Access Compliance Report

Public Rights-of-Way

Intersection ID: 21572	Main Street: GONEAWAY_RD	Cross Street: PARK_RD	Location: SW
ADA ID: 1F6EC9072768	Ramp Type: PerpDiag	Initial Pass/Fail: Fail	Overall Compliance: No
		Severity Score: 25

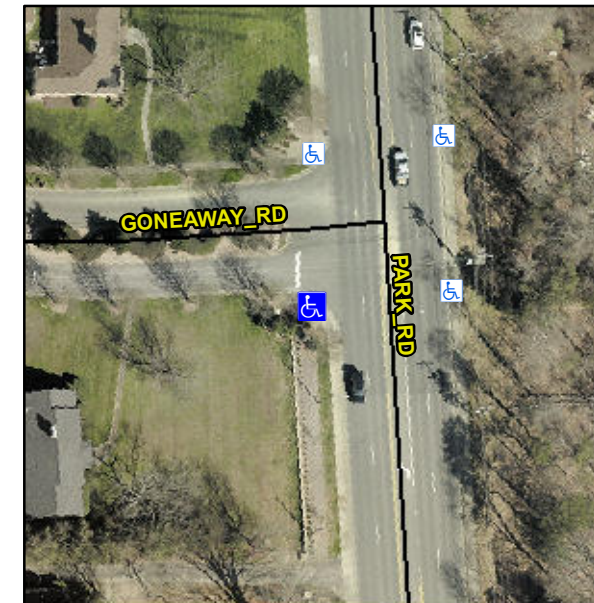
Not Found, R304.2.2, R304.5.3

Compliance	Description	Data	Compliance	Description	Data
N/A	Ramp Length (in)	59.0	No	Ramp Slope (%)	10.1
Yes	Ramp Width (in)	48.0	No	Ramp XSlope (%)	5.9
N/A	Flare Type LT	N/A	N/A	Flare Type RT	N/A
N/A	Flare Slope LT (%)	N/A	N/A	Flare Slope RT (%)	N/A
N/A	Flare Traversable LT?	N/A	N/A	Flare Traversable RT?	N/A
N/A	Landing Length (in)	N/A	N/A	DWS Provided?	N/A
N/A	Landing Width (in)	N/A	N/A	DWS Contrast?	N/A
N/A	Landing Slope (%)	N/A	N/A	DWS Length (in)	N/A
N/A	Landing X Slope (%)	N/A	N/A	DWS Full Width?	N/A
N/A	Landing Curb? (Y/N)	N/A	N/A	DWS Offset (in)	N/A
N/A	Shared Landing?	N/A			
N/A	Gutter Ponding?	N/A	N/A	Gutter Slope (%)	N/A
N/A	Gutter Lip Ht (in)	N/A	N/A	Gutter X Slope (%)	N/A
N/A	Painted X Walk1?	No	N/A	Painted X Walk2?	No
	X Walk 1 Direction	To E		X Walk 2 Direction	To N
N/A	X Walk 1 Width (in)	N/A	N/A	X Walk 2 Width (in)	N/A
	X Walk 1 Slope (%)	1.9		X Walk 2 Slope (%)	0.4
	X Walk 1 X Slope (%)	4.8		X Walk 2 X Slope (%)	5.4

Remove & Replace Curb Ramp With Two New Directional Ramps or Equivalent.
